Re: Appeal of Use Permit Approval for 320 Sheridan Drive Project

I am writing to formally appeal the Planning Commission's decision on January 13, 2025, approving the Use Permit for the proposed project at 320 Sheridan Drive, in Menlo Park.

**EXHIBIT A-3: Aerial photo of project area**

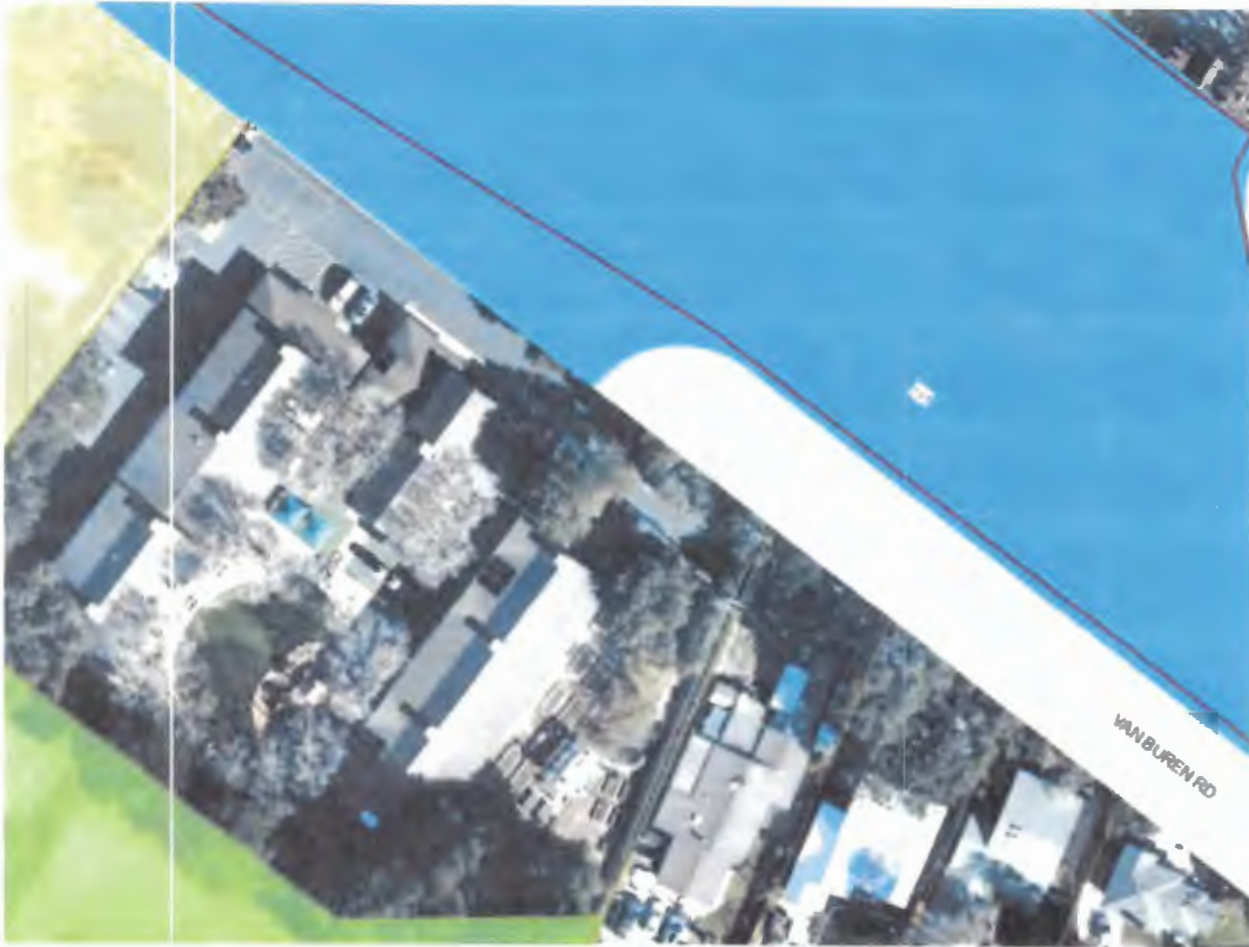
**EXHIBIT A-1: Map of Caltrans ROW depicts that it can accommodate extension of Van Buren Road:** Caltrans owns a strip of land between the Haven House property line at the end of Van Buren Road, and the Hwy 101 Freeway wall (as seen in photo with a few trees and crude path). This parcel is currently undeveloped and wide enough to create a 2-lane extension from Van Buren Road to the new development in the upper left.

**EXHIBIT E: TDM Plan depicts bicycle route to MP Caltrain station via a “second entrance/egress” on Van Buren Road, which is NOT included in the project plan. (p. 11, A178 in packet)**

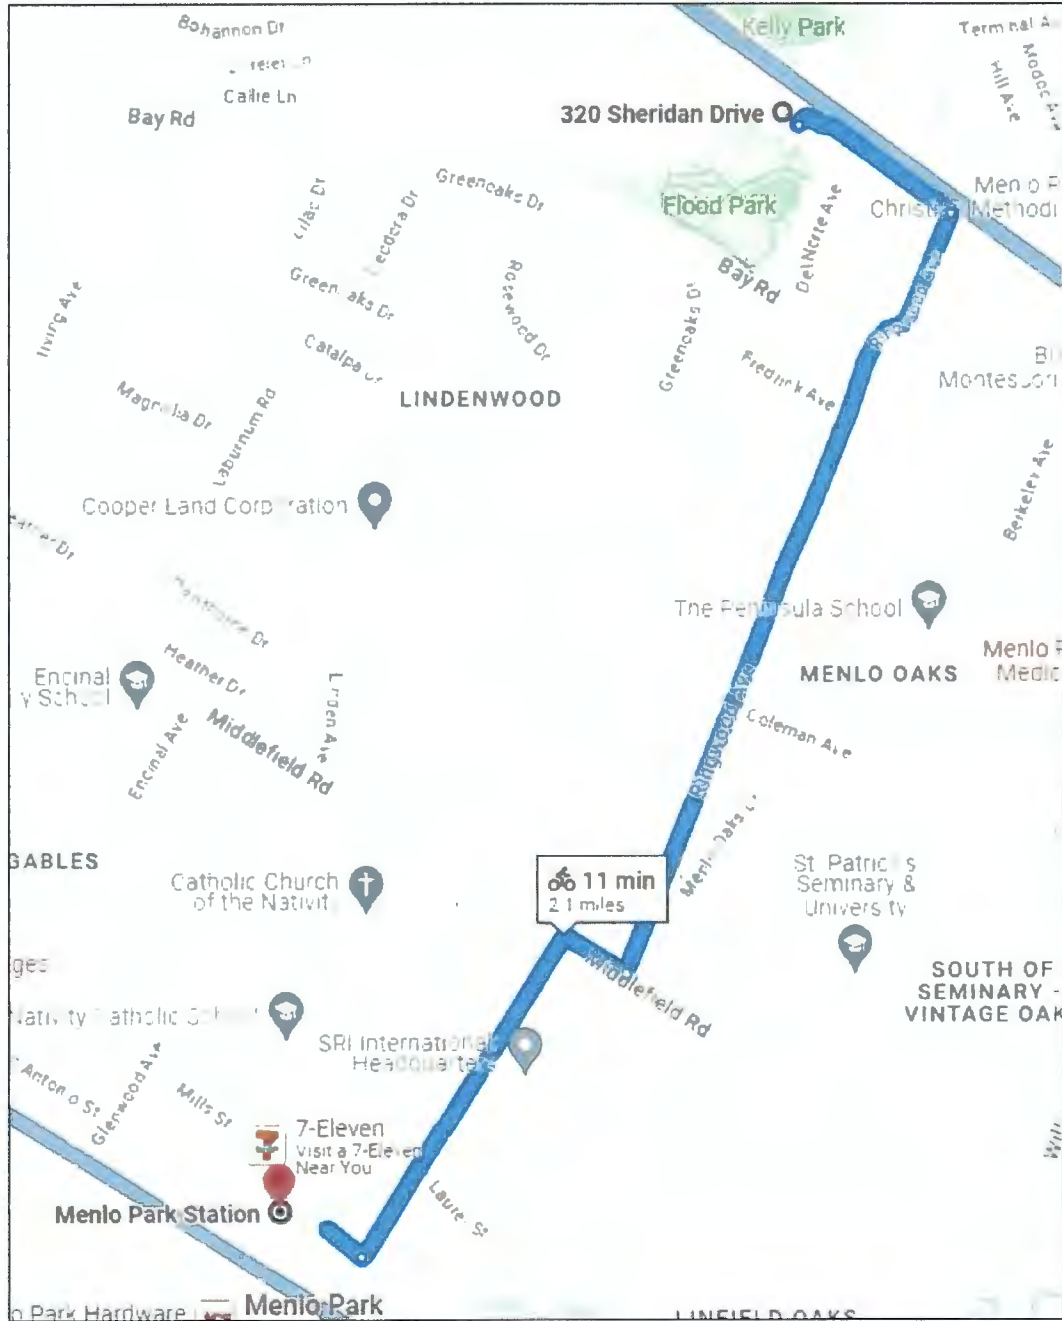
Even more confusing, the TDM provides a bike route map (EXHIBIT E) that illustrates residents of 320 Sheridan *can* ride their bicycles to CalTrain Menlo Park station via a second entrance/exit on Van Buren Road (page 11; p. A178 of the packet), when in fact this entrance is currently proposed as an emergency-only gate and not available for bike/ped access.
